NEW Adjustable lock plate

in production from February 2013

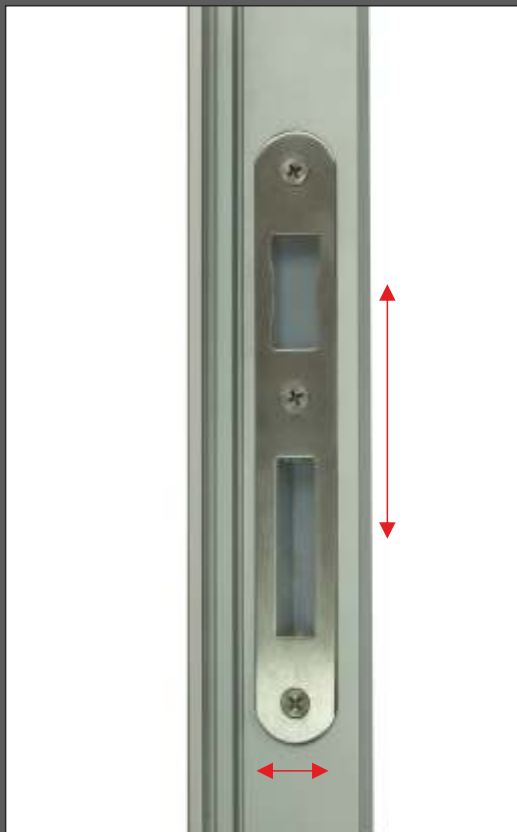
A new type of lock plate will be in use soon for most of pass doors, side doors and double wing doors. The plate is connected to the same shape plate with fixed nuts on the opposite side of door frame. After releasing screws, there is a possibility to adjust plate up/down and forward/backward in about 3 mm.
